Scientific and practical analysis of the issue of separating DI and Stop Lamps (SL) (SLR 73 08/Rev.1, SLR 75 11, SLR 75 12)

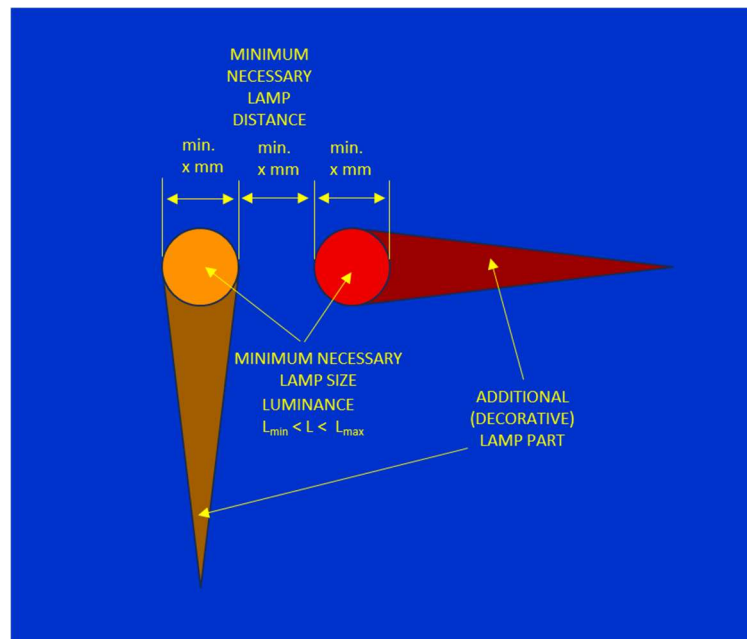
Present definition of apparent surface:

- Ignores **luminance distribution**;
- Ignores **edge contrast**;

From a human-vision standpoint, area alone is a weak predictor of salience unless luminance and contrast are controlled. Therefore, any numeric threshold (e.g. $\geq 30 \text{ cm}^2$) is at best a **proxy**, not a perceptually grounded value.
